CITY OF BERKLEY, MICHIGAN REGULAR MEETING OF THE CITY PLANNING COMMISSION

Subject: PSP-14-25 and PSU-05-25, 2960 Twelve Mile Rd. Berkley Theater – Site Plan and Special Land Use Consideration

BERKLEY ENTERTAINMENT LLC
BERKLEY THEATER
2960 W 12 MILE ROAD
SITE PLAN / SPECIAL LAND USE

Subject: **PSP-14-25 and PSU-05-25, 2960 Twelve Mile Rd. Berkley Theater – Site Plan and Special Land Use Review**

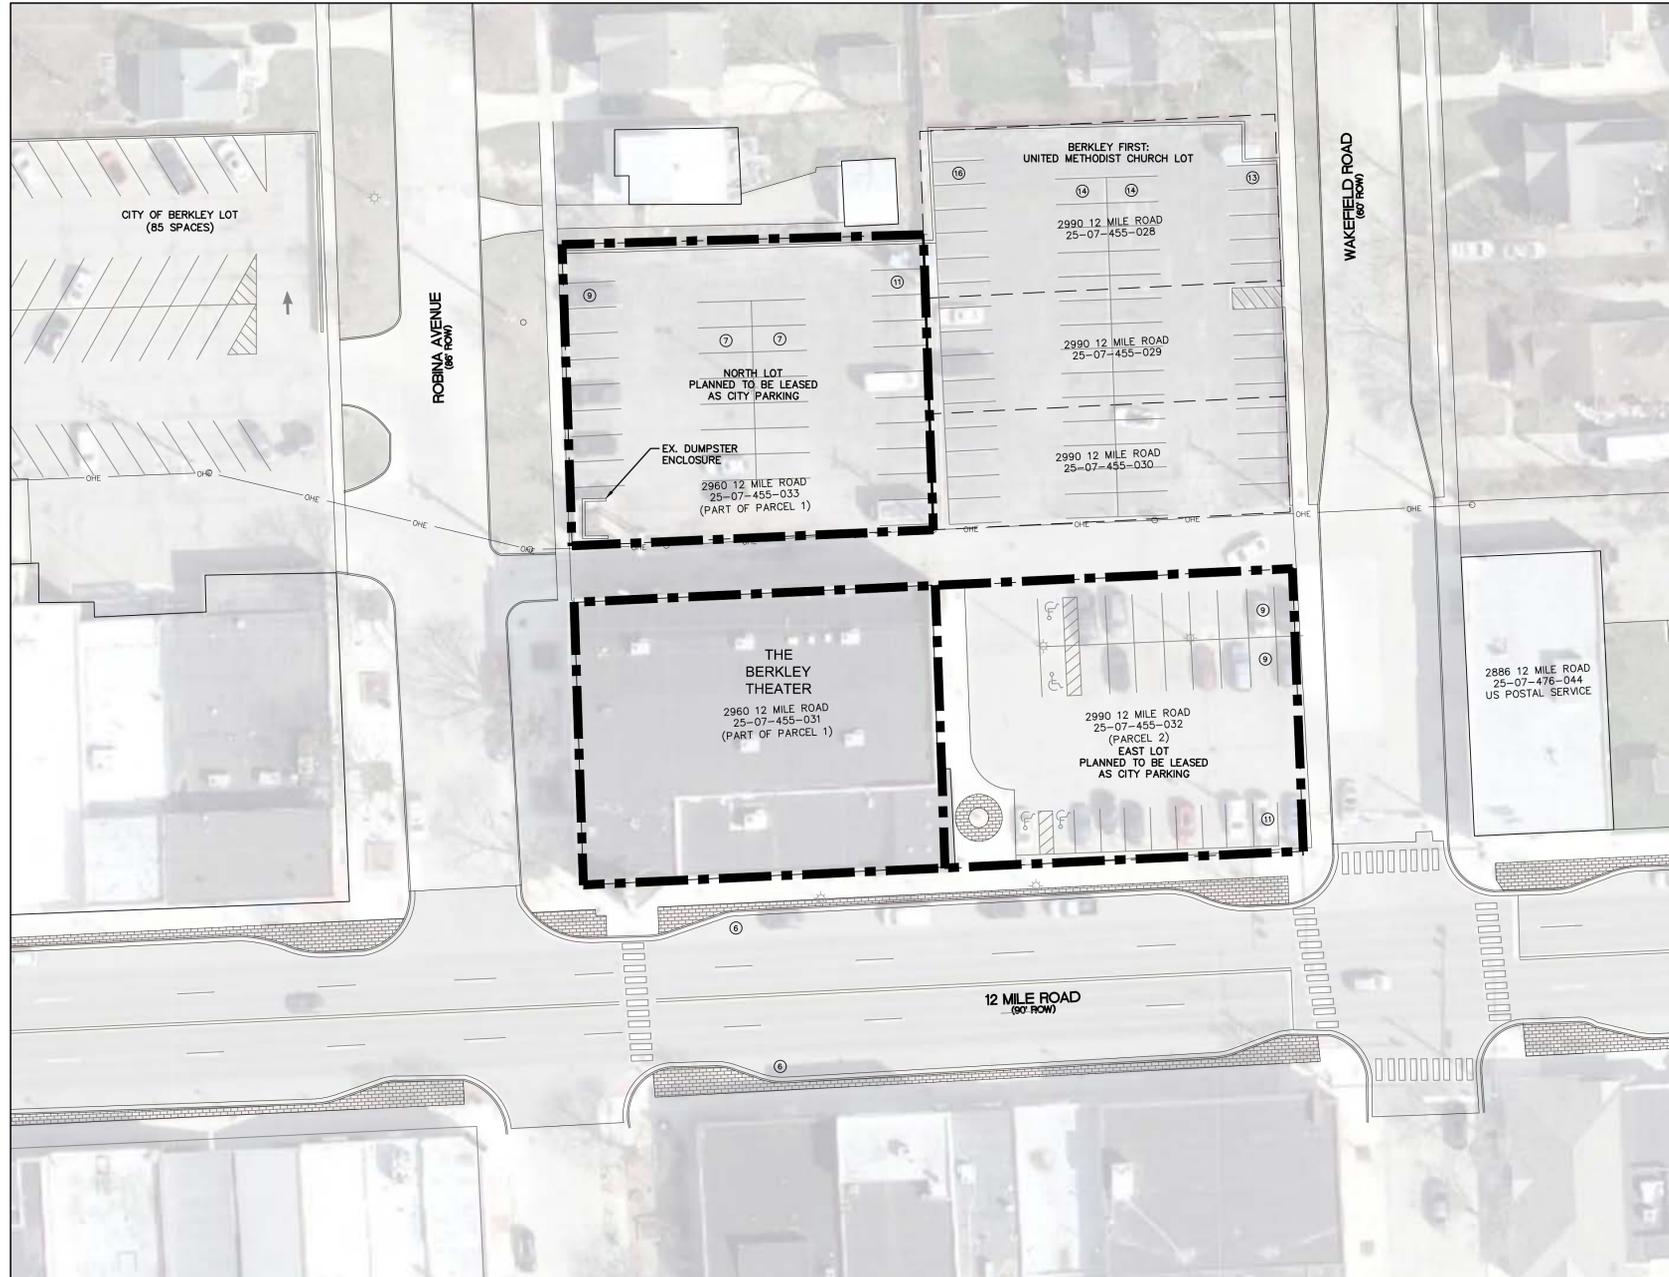
The proposed façade change requires review and approval by the Planning Commission. Updated ordinance standards can be applied in instances where revisions to the façade or site are proposed. For example, since window modifications are proposed for the Twelve Mile Rd. façade, current transparency standards would apply, but since site work is not proposed, required landscaping would not apply. Staff comments are italicized with items to be addressed after Planning Commission consideration bolded.

4. The plans indicate parking lot and wall pack lighting will be replaced as necessary if fixtures are found to be faulty. Specification sheets have been included and replacement would take place as part of future electrical work. ***The following notes should be added to the plan.***

Figure 1: Area within 10-minute walking distance from 2960 12 Mile Rd

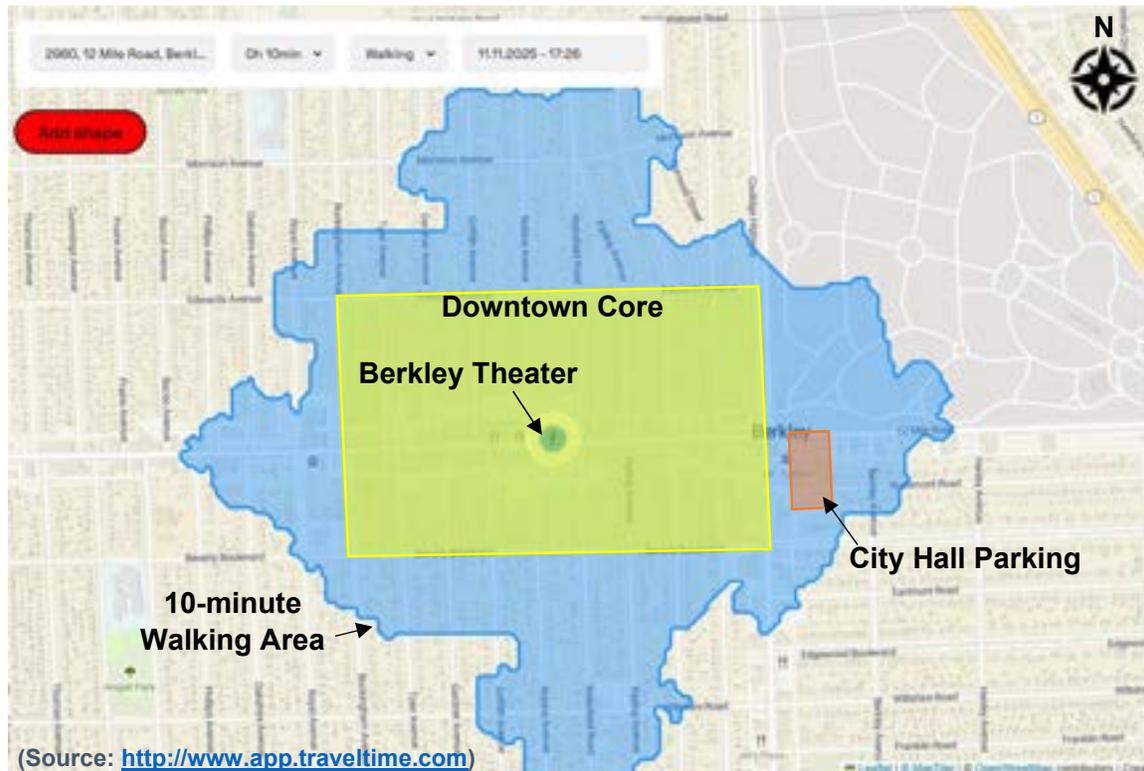
Within an assumed 10-minute walk to the venue, there are several on-street parking blocks and municipal lots. This can be seen in **Figure 1**, which is a travel time shape known as an isochrone that visualizes reachable areas within a given timeframe, and is more realistic than a circular shape. TravelTime considers an approximate 4.5 ft/s walking speed, so the figure above may slightly overestimate walking distances, but gives a good representation for preliminary considerations. As can be seen in **Figure 1**, a 10-minute walking distance covers nearly all of downtown Berkley on 12 Mile Rd, some of the Coolidge district, and many residential blocks. This includes an area which expands to the parking lots at City Hall.

SD cannot provide exact values of available on-street parking at this time. However, assuming that the nearby municipal lots are available for attendees and City Hall lots for staff, the typically small overflow parking need is anticipated to be easily accommodated by street parking within a 10-minute walk. For events that exceed the typical 544 occupant capacity, SD would recommend that special event plans be put in place through coordination between the City and the owner. This could include special permits to utilize school parking lots (such as those at Berkley High) or partnering with other private lot owners for lot usage (such as those farther east on 12 Mile Rd).

SD recommends the City consider allowing the theater's parking requirement to be accommodated via a combination of municipal lots and on-street parking within a 10-minute walk. While an exact response on downtown due to theater parking cannot be ascertained at this time, SD feels that this unique solution could be a sufficient method to accommodate the new land use's parking needs. Approving the new venue would revitalize an underused community landmark downtown. The Berkley Theater can once again act as a community resource, a regional draw to visitors, and strengthener of other DDA businesses.

BERKLEY ENTERTAINMENT LLC
BERKLEY THEATER
2960 W 12 MILE ROAD
SITE PLAN / SPECIAL LAND USE

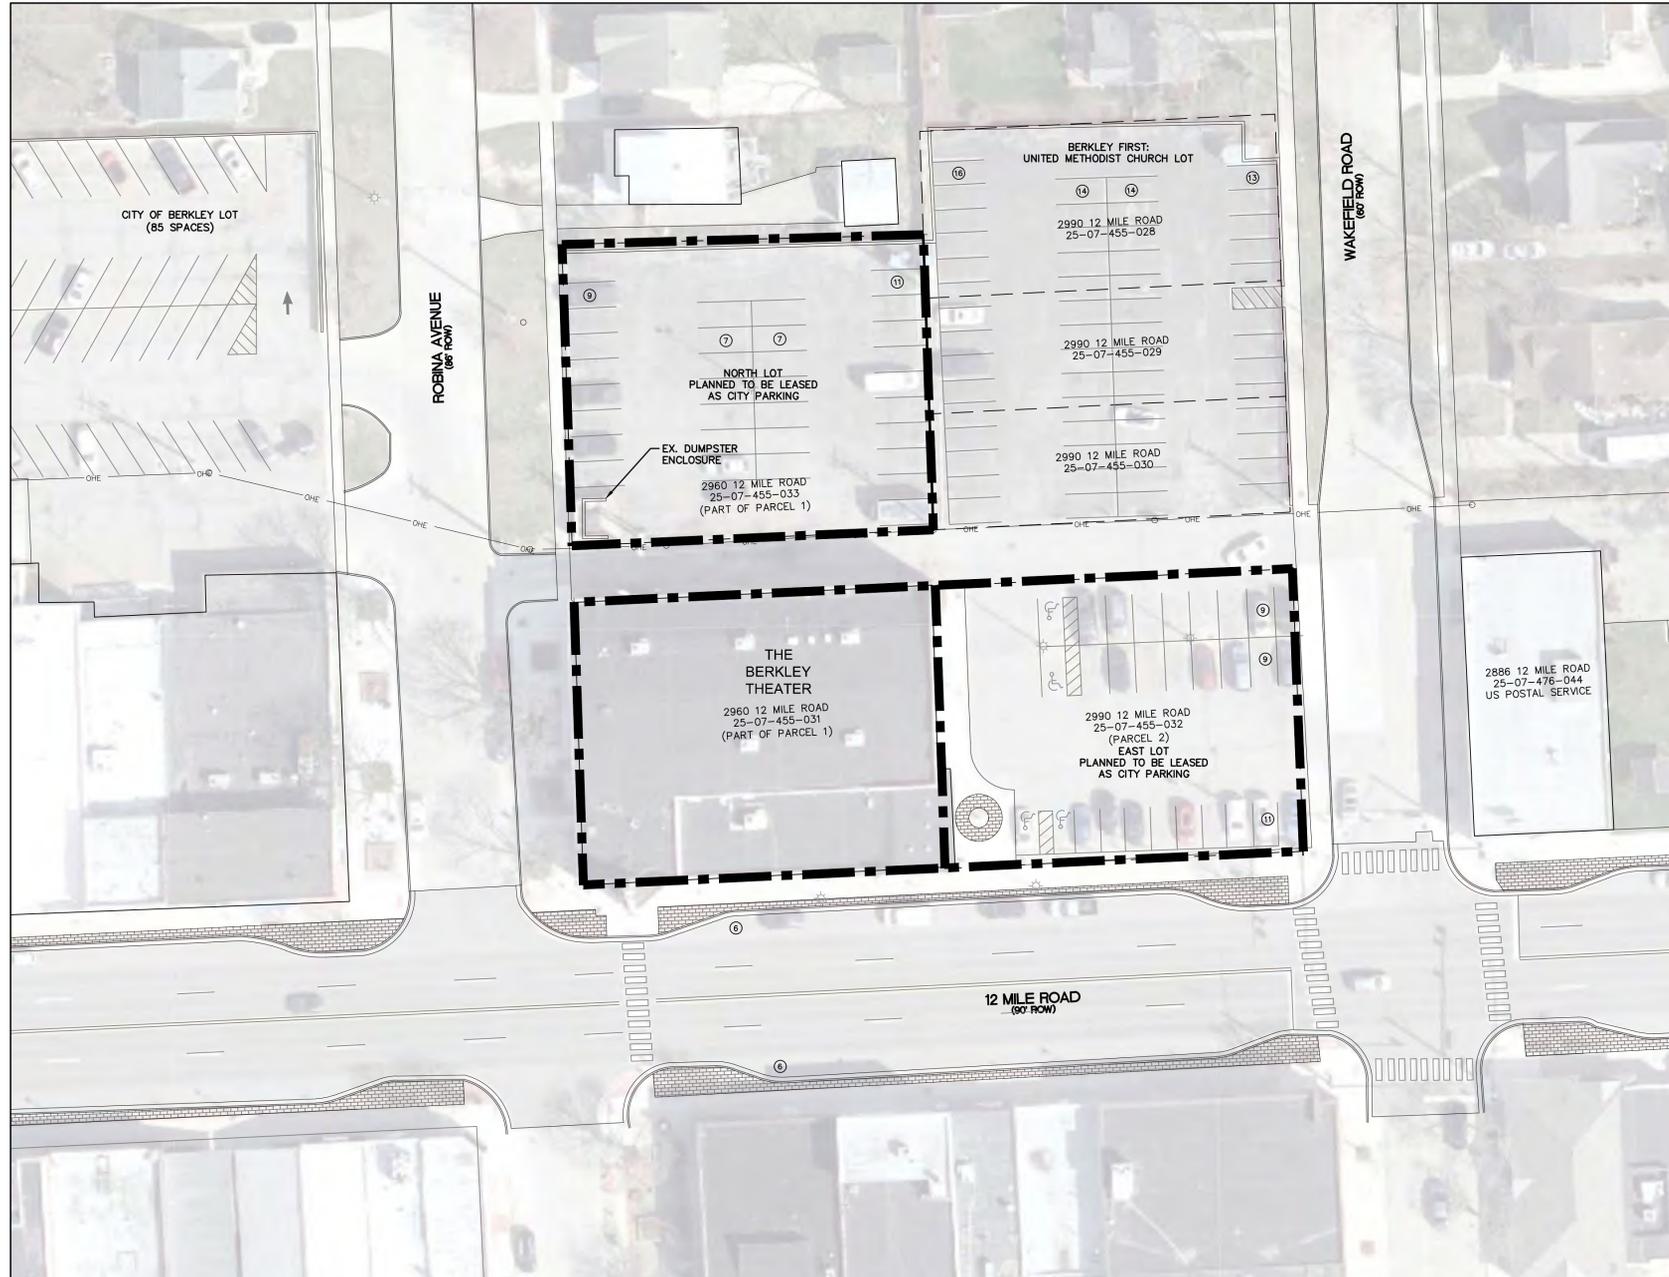
- ▶ **SITE PLAN** – a previous version of the site plan indicated requirements of 1 space per 3 occupants (i.e., 182 spaces). The current (and previous site plans) indicate that the theater’s parking demand would be covered by **200 spaces** in several lots and on-street parking surrounding 2960 12 Mile Rd. This includes using 57 spaces in the parking lot of the Berkley First United Methodist Church.

- This includes use of three existing City parking lots (North Lot, East Lot, and lot west of Robina), as proposed by the developer on the site-plan. In this scenario, SD assumes the availability of parking given the timing of the events at non-peak hours.

- Per the site plan, the three lots surrounding the theater have a total of 120 parking spaces, North = 34, East = 29, and Church = 57. The Robina lot is indicated to have 85 spaces.

- ▶ **ZONING ORDINANCE** – The source of the site plan parking requirement plan is not cited, however, the Berkley Zoning Ordinance (effective April 16, 2025) indicates a minimum requirement of 1 space per 4 seats (i.e., 107 spots considering 426 attendees).
